Northwestern Water and Sewer District  
2024 McClure Westside Water Main Replacement  
WL-2906

**ADDENDUM 4**

July 29, 2024

SURFACE RESTORATION DETAILS  
 NORTHWESTERN WATER & SEWER DISTRICT, OHIO  
 2024 MCCLURE WESTSIDE WATER MAIN REPLACEMENT WL-2906

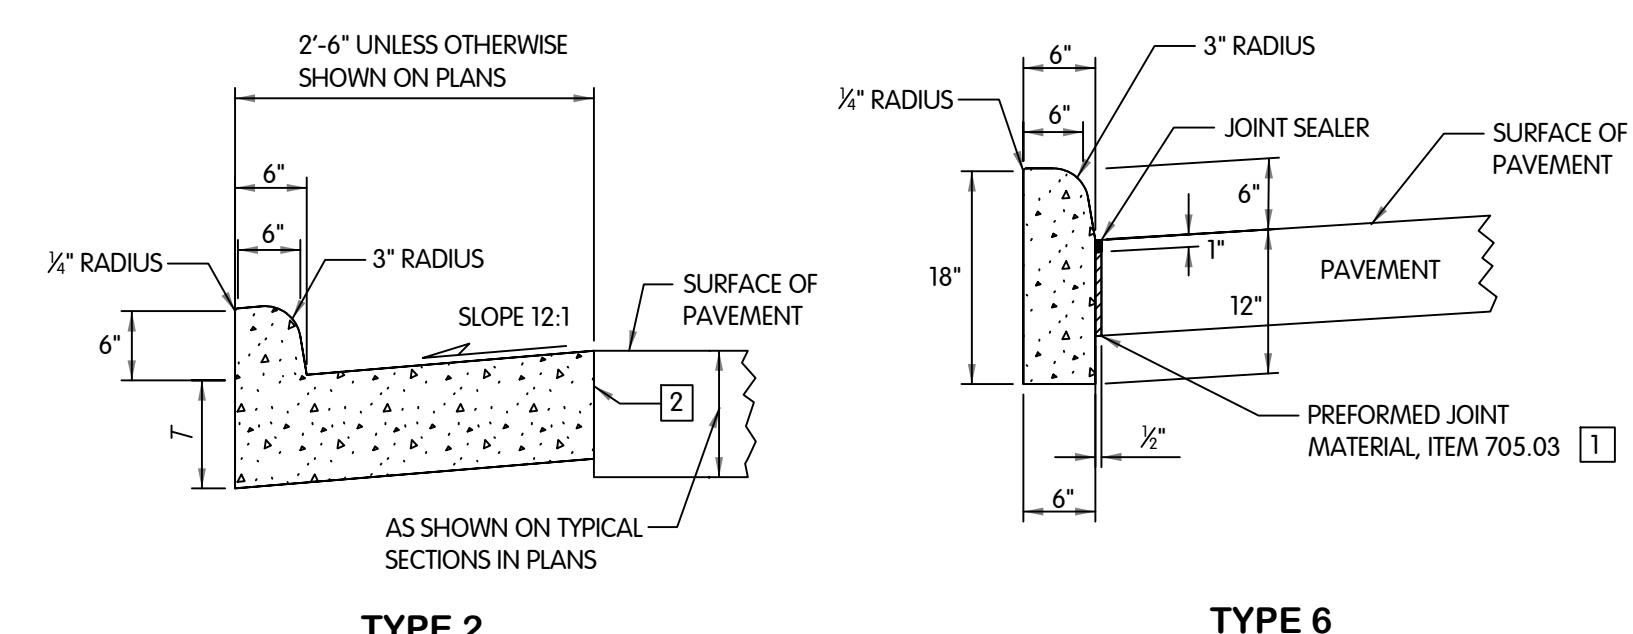
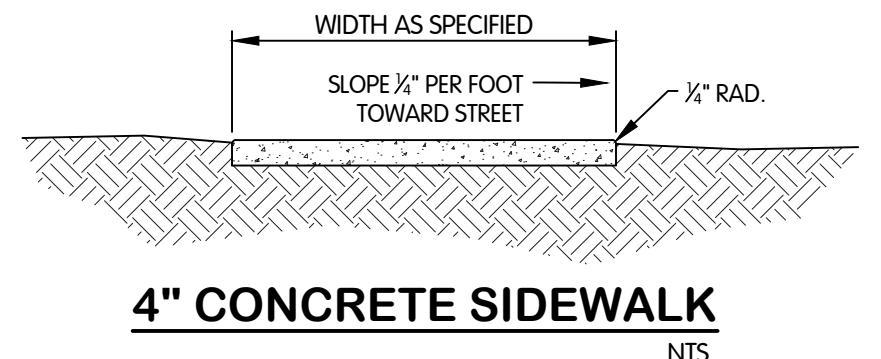
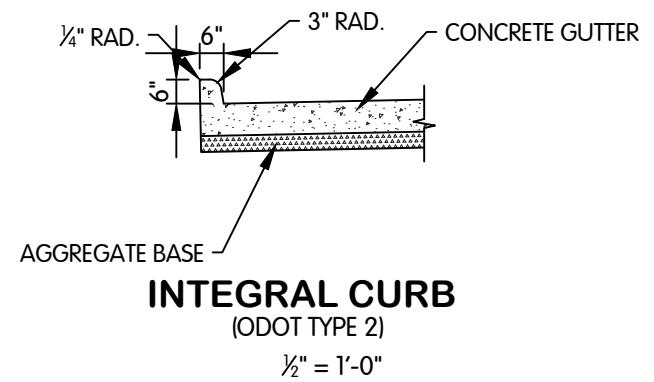
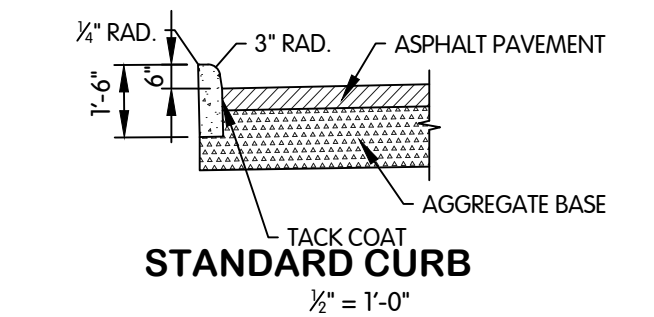
Replace Sheet SR-0.1 with the attached sheet that shows planing detail.

***Question #4 – For the “Trench Patching” it calls for matching the existing pavement, what is the minimum thickness required?***

***Question 5 – For the street overlay, what is the thickness of Asphalt Pavement to be milled and what is the thickness of the Asphalt Overlay?***

15 inches. See Drawing Sheet SR-0.1, Pavement Trench Repair Typical Section.

1 ¼ inches. See the updated Drawing Sheet SR-0.1.
